Access Compliance Report

Public Rights-of-Way

Intersection ID: 14648	Main Street: EAST_BV	Cross Street: LENNOX_AV	Location: W
ADA ID: 7BC2EAE657ED	Ramp Type: Directional1	Initial Pass/Fail: Pass	Overall Compliance: No
		Severity Score: 0

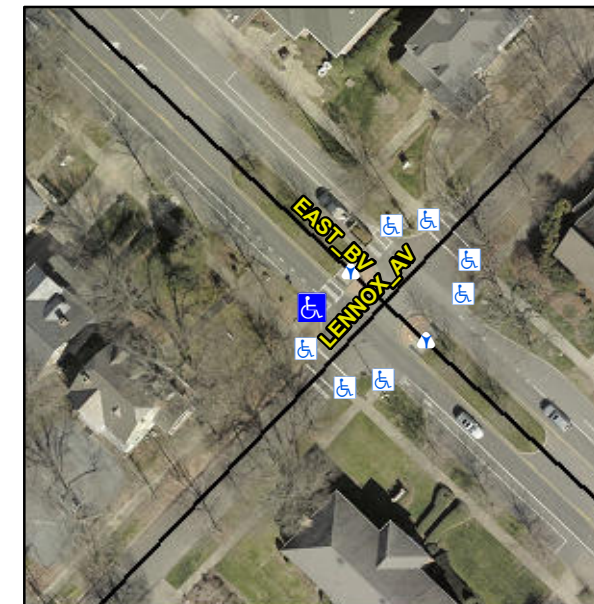
R304.2.2-Perp, R304.3.2-Para

Remove & Replace Landing.
